PLANS AND DOCUMENTS
referred to in the PDA
DEVELOPMENT APPROVAL

Approval no: DEV2021/1226
Date: 1/04/2022

Flagstone Centrestore

1 Homestead Dr, Jimboomba QLD 4280

DRAWING NAME
RETAIL ELEVATIONS

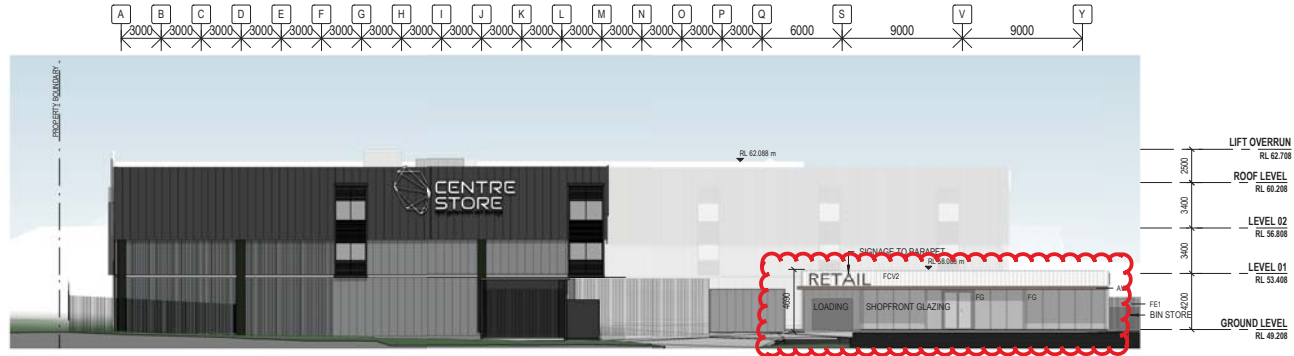
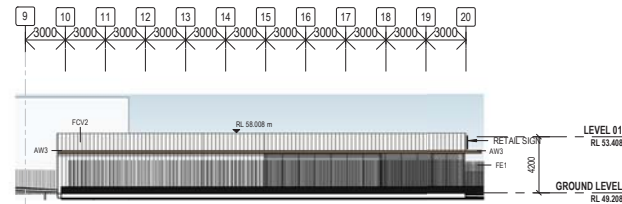
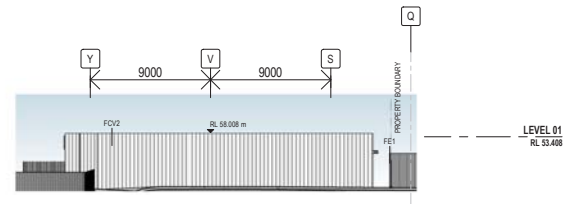
AMENDED IN RED

Glazing to front of retail use to be a minimum 60% of frontage.
